STAFF SUMMARY FOR CASE: VAC-25-0007

REQUEST TO VACATE EAST 9th STREET ROW AND NORTH & SOUTH ALLEYS ROW IN THE 800 & 900 BLOCKS BETWEEN N MAIN STREET & N VIRGINIA AVENUE

Roswell Planning & Zoning Commission

Tuesday, April 1, 2025

**EXCERPT OF PRELIMINARY EAST 9th ST. R.O.W. VACATION REPLAT
BY SMITH ENGINEERING CO. (See Exhibit F)**

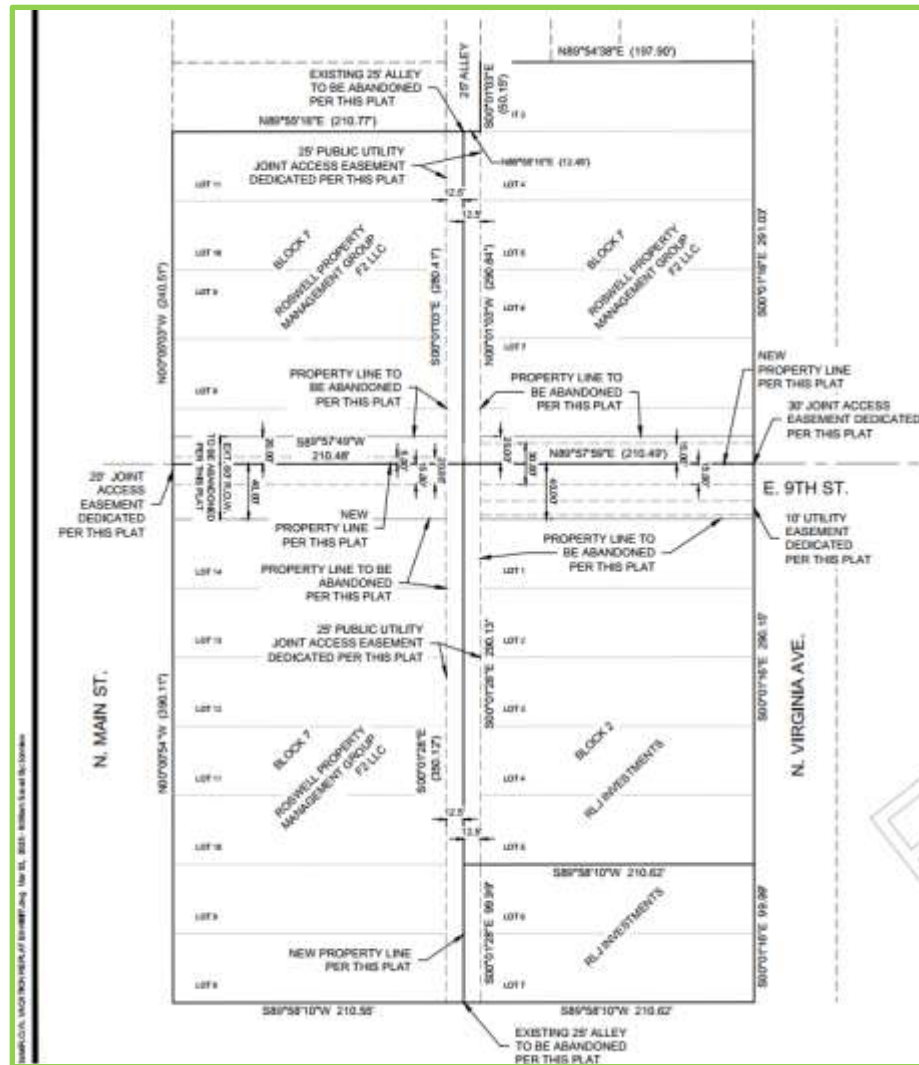
3. An excerpt from the Preliminary **EAST 9th ST. R.O.W. VACATION REPLAT BY SMITH ENGINEERING CO.**, is provided below and in its entirety in **Exhibit F**.
4. The Vacation Replat shows the following: Vacate East 9th Street ROW and adjacent south Alley ROW and portion of adjacent north Alley ROW to consolidate properties on the north and south sides of East 9th Street between Main Street and Virginia Avenue for infill development; to abandon property lines and create new property lines; and dedicate joint access easement(s), joint public utility and access easement(s), and utility easement(s) by the replat.

**Map of East 9th Street 60' wide Public R.O.W. Vacation Area (yellow)
& vacation of 25' wide Public Alley R.O.W. (blue)
with conversion to utility and access easements
by Smith Engineering Co. (See Exhibit F)**

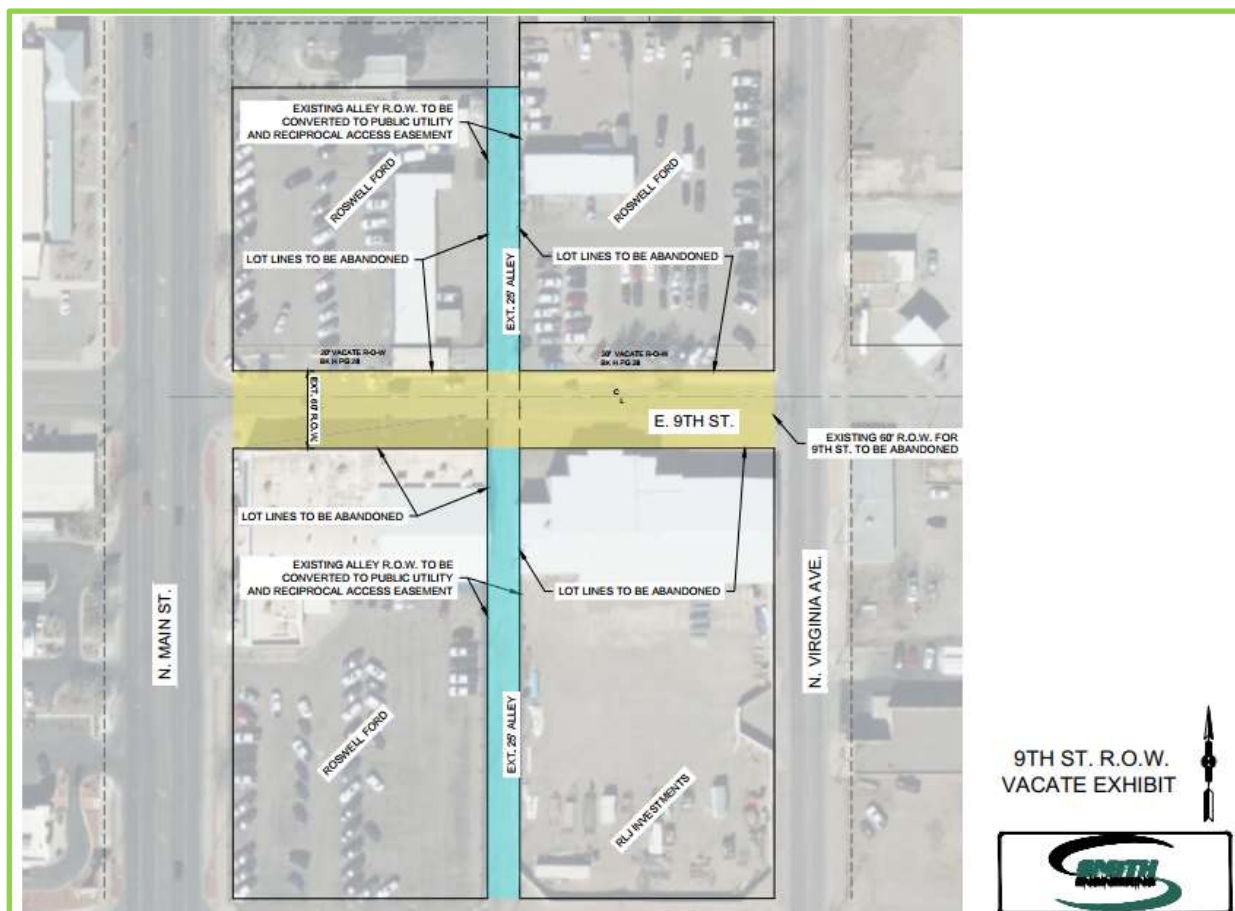
5. The following map provided by Smith Engineering Co., is an exhibit that accompanies the Replat to visually show the E 9th Street and Alleys under consideration for vacation. (See **Exhibit F.**)

EXHIBIT G VAC-25-0007: ROSWELL FORD E 9TH STREET SERVICE LANE CONCEPT

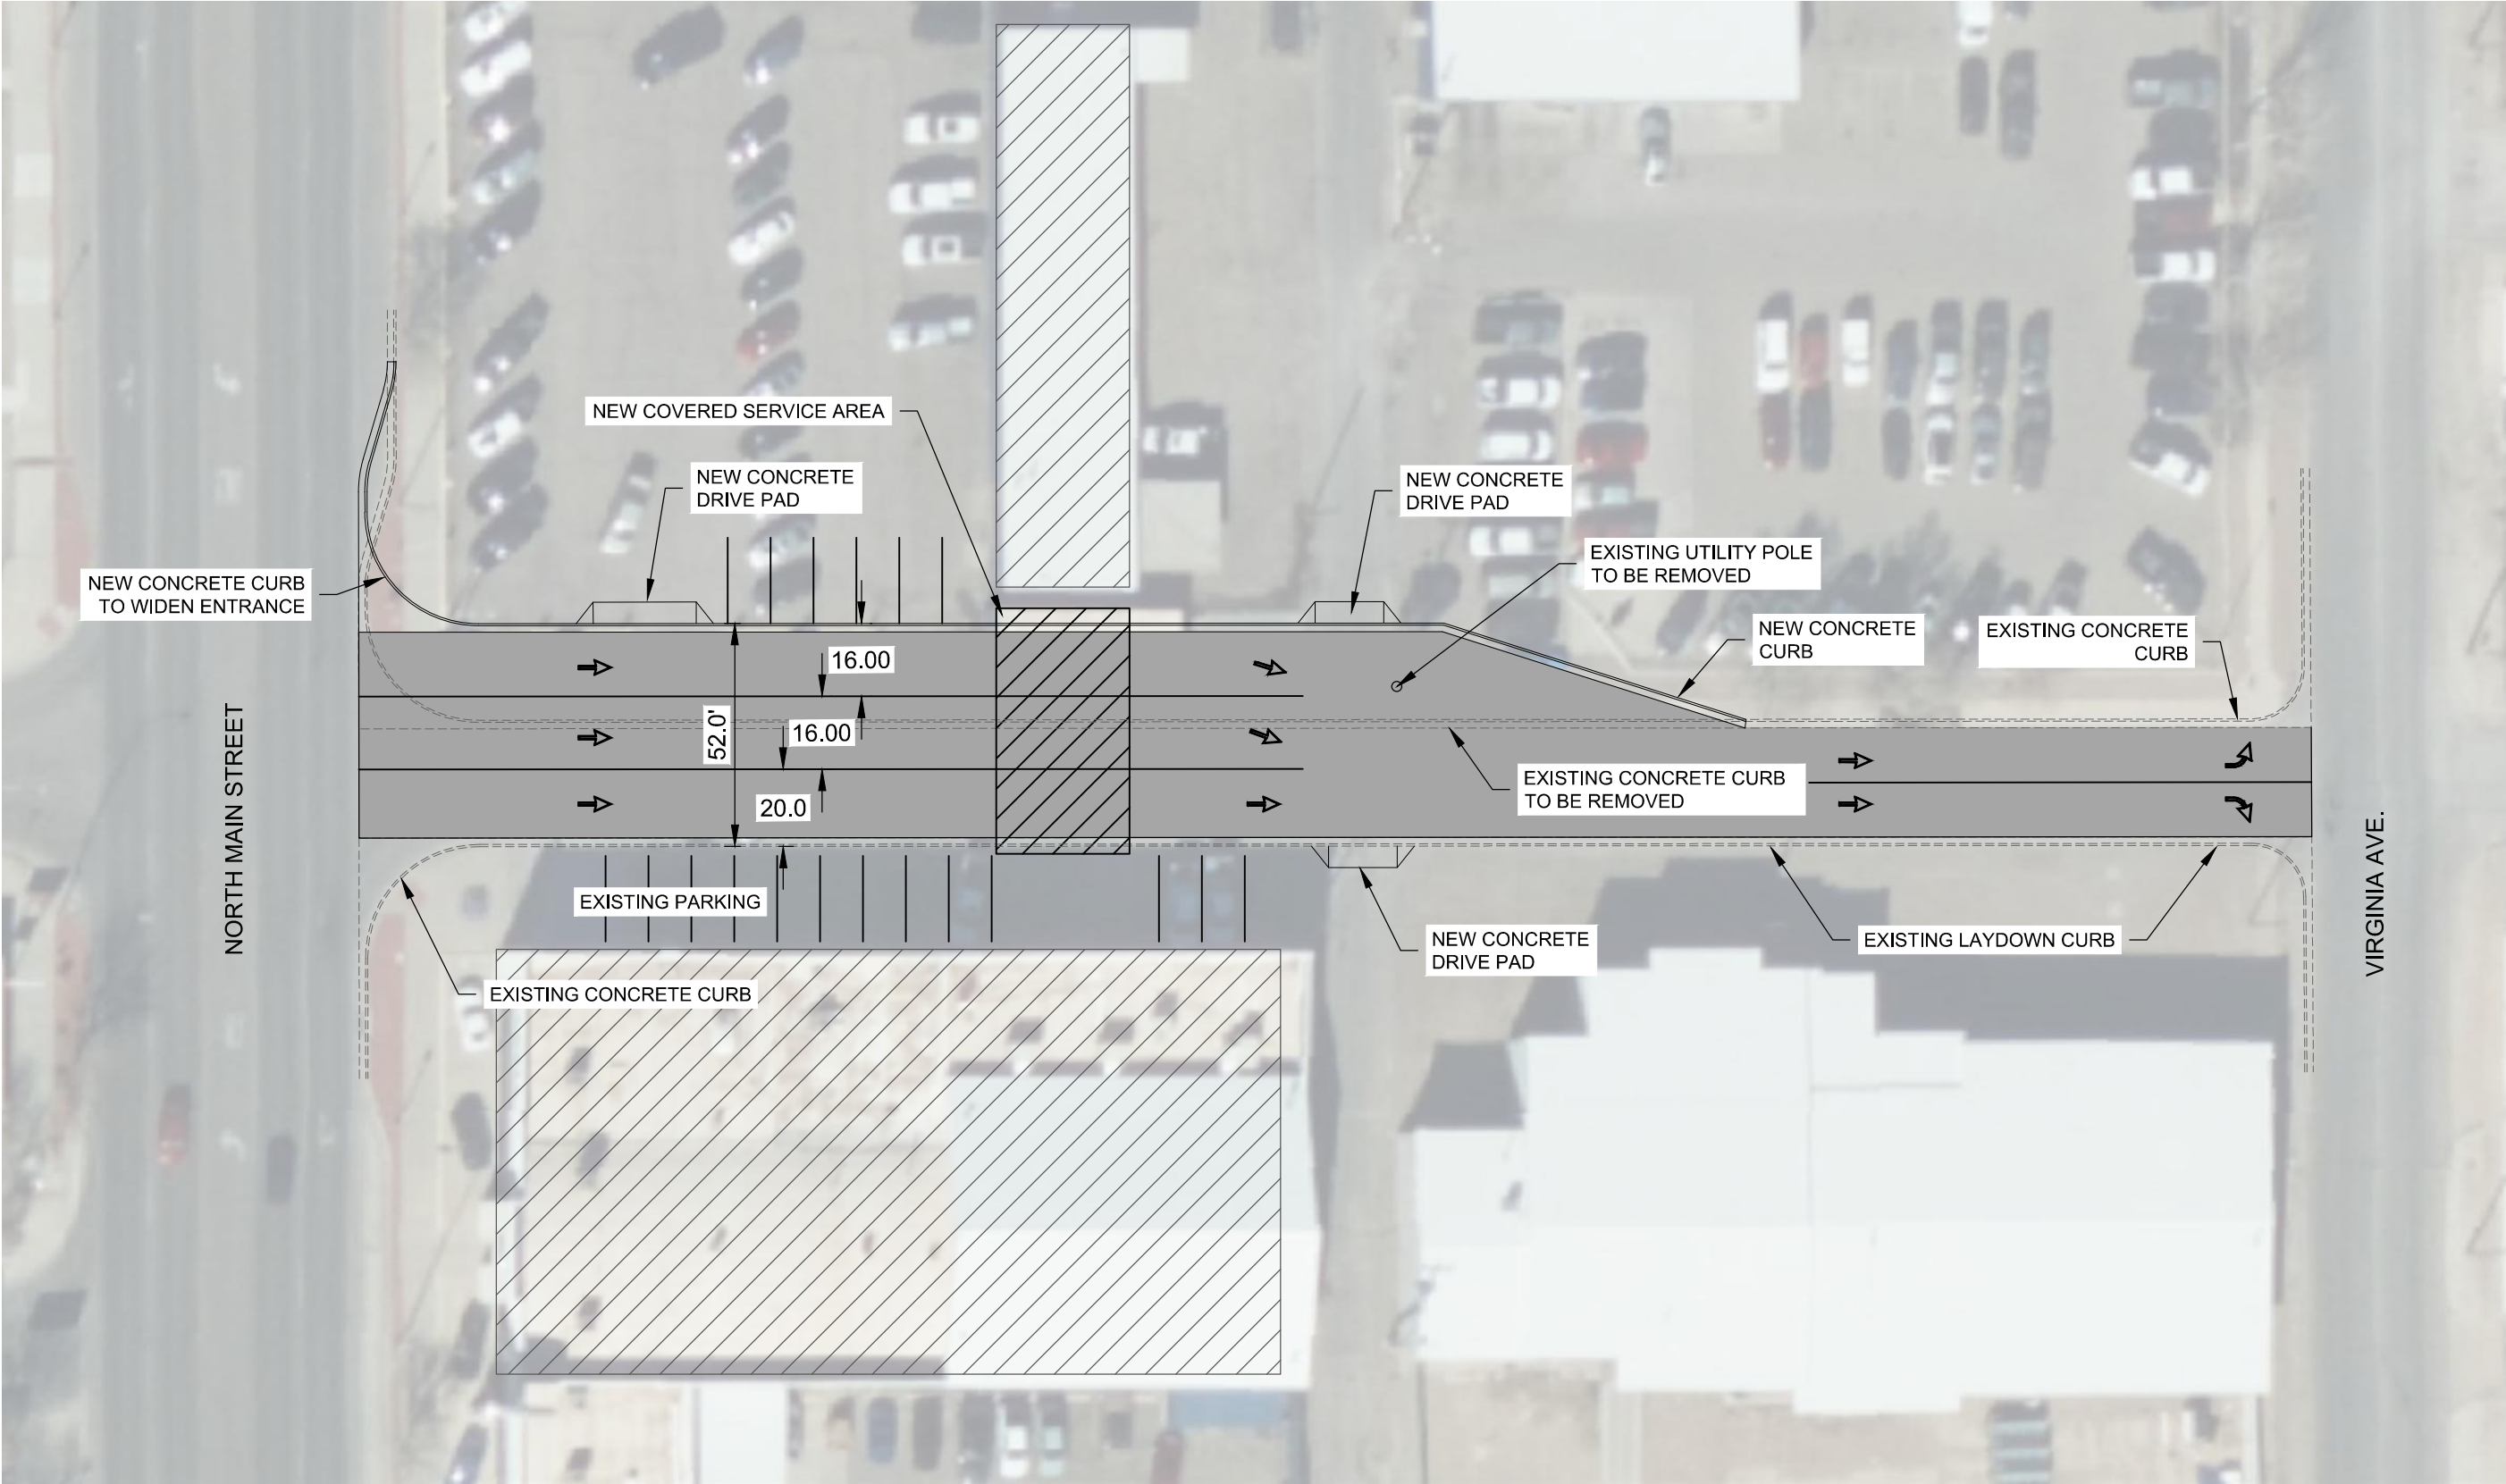
"Just to confirm what Scott said and keep track of our discussion; we noted the need for signage through the open 20ft service lane indicating that it would be used as a Fire Lane, the height of the canopy would be large enough to facilitate the largest aerial apparatus we may have, and the alley gates will have knoxbox access at each point."
10. As classified on the 2016 Functional Street Classification Plan
 - 9th Street is a Local Street,
 - Main Street is a Principal Arterial, and
 - Virginia Avenue is a Minor Arterial.
